INTERNATIONAL CODE COUNCIL

2009/2010 CODE DEVELOPMENT CYCLE

PROPOSED CHANGES TO THE 2009 EDITIONS OF THE

October 24 2009 – November 11, 2009

RP13-09/10
P2904.2.4.2, Table P2904.2.4.2 (New)

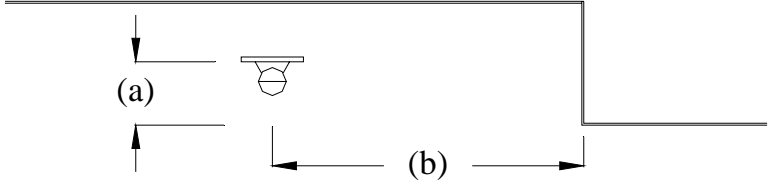
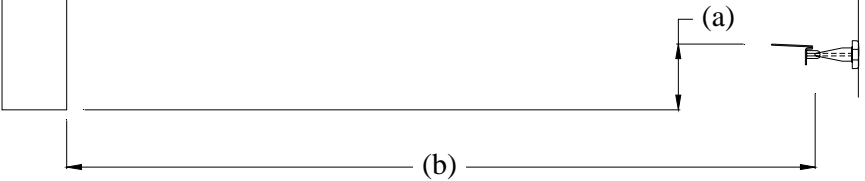
1. Revise as follows:

P2904.2.4.2 Obstructions to coverage. Sprinkler discharge shall not be blocked by obstructions unless additional sprinklers are installed to protect the obstructed area. Additional sprinklers shall not be required where the sprinkler separation from obstructions shall comply with the greater of the minimum distance indicated in Table P2904.2.4.2 and the minimum distances specified in the sprinkler manufacturer's instructions.
